Access Compliance Report Public Rights-of-Way (Pedestrian Signals)

Main Street: GILBERT_ST Cross Street: BALL_RD Location: NE

ADA ID: SGRK210927171536 Signal Type: One Push Button-Non APS Overall Compliance: No Severity Scores: BTN 1: 25 BTN 2: N/A No BTN: N/A

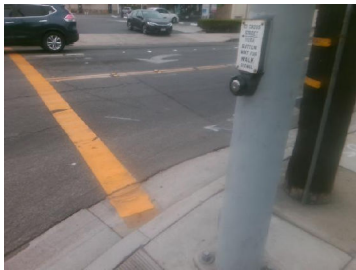
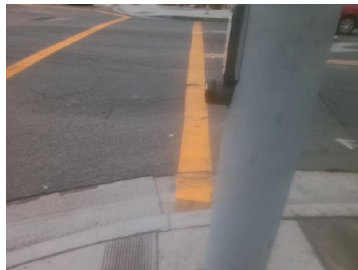
OC Std/PROW: R404.2, R404.3

Possible Solutions: Remove and Replace Clear Space.
